ADDENDUM #1

TO: ALL PLAN HOLDERS AND POTENTIAL BIDDERS
FROM: TIFFANY McCANTS, PURCHASING OFFICER
SUBJECT: A.C. REYNOLDS MIDDLE SCHOOL RESTROOM REMODEL
(RFP# 26-19)

SUBJECT: AC Reynolds Middle School- Lower Level Restrooms – Addendum 1

3 ENLARGED PLAN- PROPOSED
1/4"=1'-0"

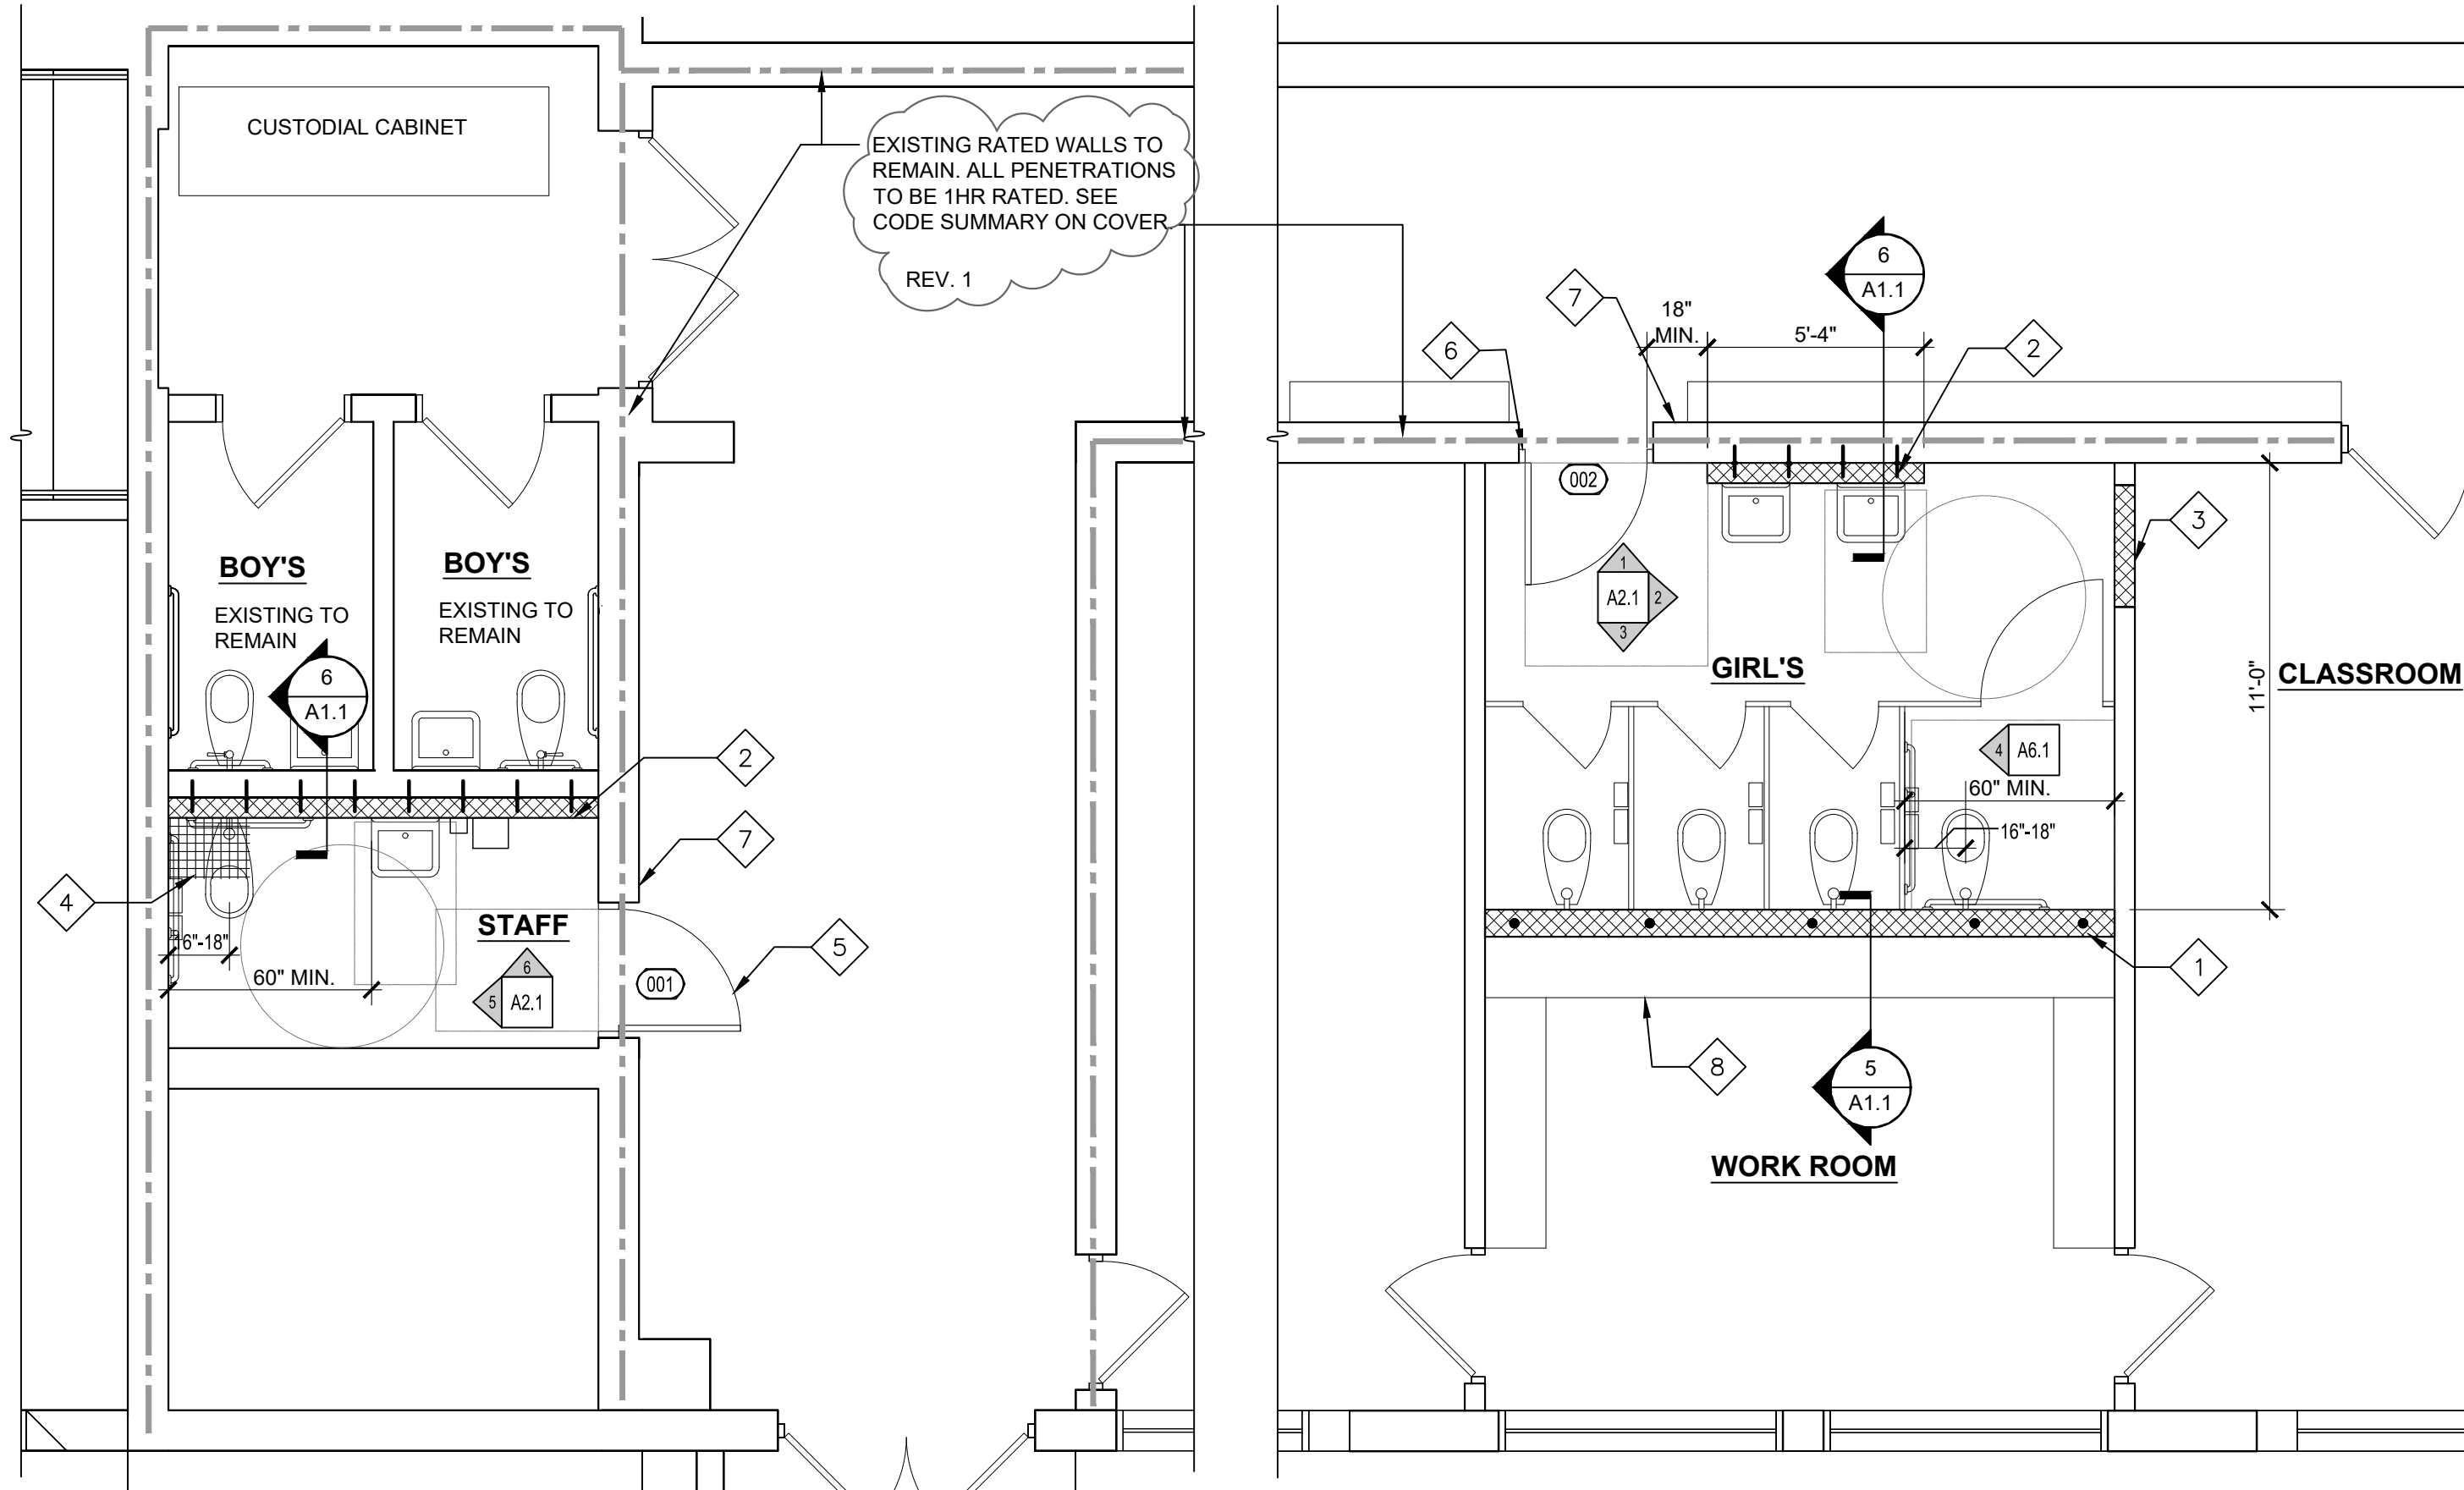
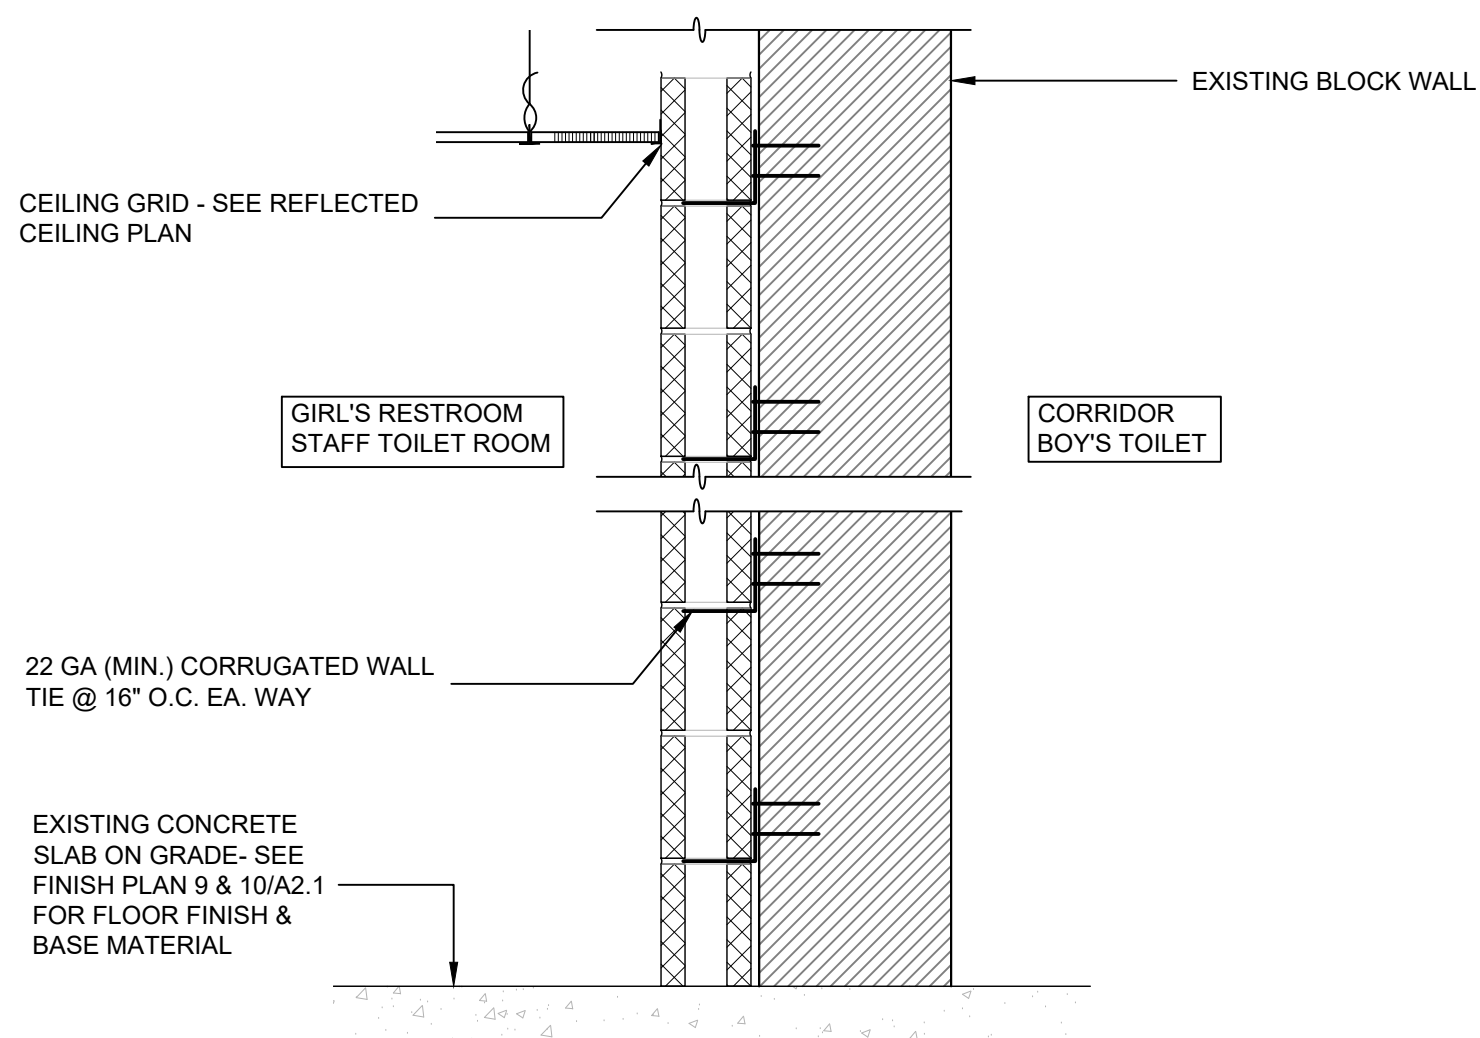
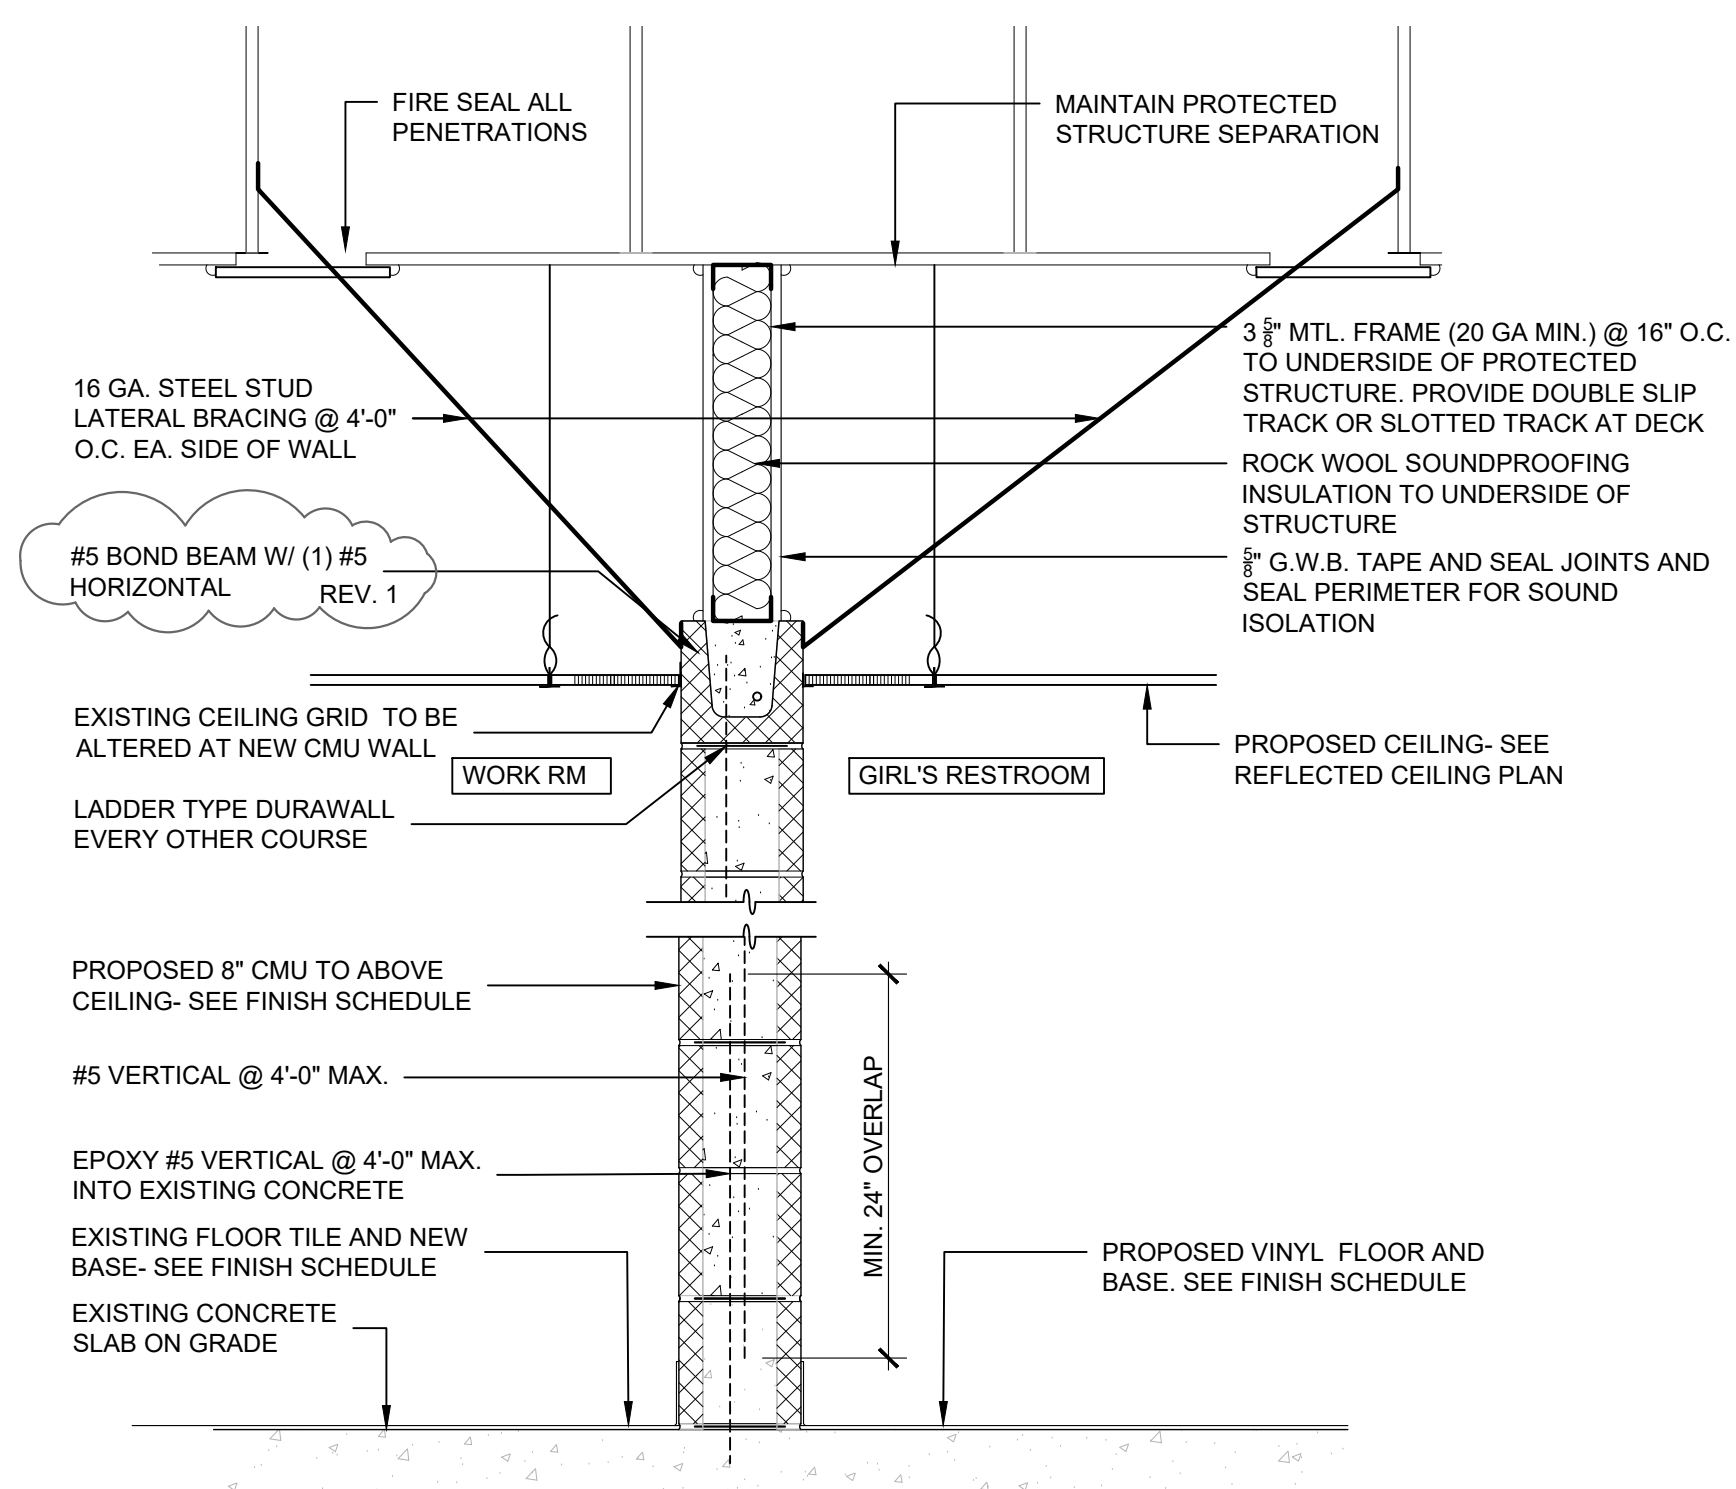
- 1 PROVIDE NEW CMU WALL PER SECTION 5/A1.1
- 2 PROPOSED 6" CMU WALL TO ABOVE CEILING- CORRUGATED BRICK TIES @ 16" O.C. EA. WAY SEE SECTION 6/A1.1
- 3 INFILL EXISTING DOOR OPENING W/ BLOCK TO MATCH- PATCH AND PAINT- BOTH SIDES
- 4 PATCH WITH 2"x2" CERAMIC MOSAIC TILE WHERE SERVICE SINK IS TO BE REMOVED. MATCH EXISTING TILE
- 5 NEW DOOR AND FRAME IN EXISTING BLOCK OPENING. SEE H-2, J-2 AND DOOR SCHEDULE.
- 6 NEW DOOR AND FRAME IN PROPOSED OPENING. SEE H-1, J-1, S-1 AND DOOR SCHEDULE.
- 7 PROVIDE NEW RESTROOM SIGN TO MEET ADA REQUIREMENTS
- 8 PROVIDE AND INSTALL 27 LF X 5 HIGH (3" X 18" D) MELAMINE SHELVING ON HEAVY DUTY STANDARDS AND BRACKET @ 16" O.C. REV. 1
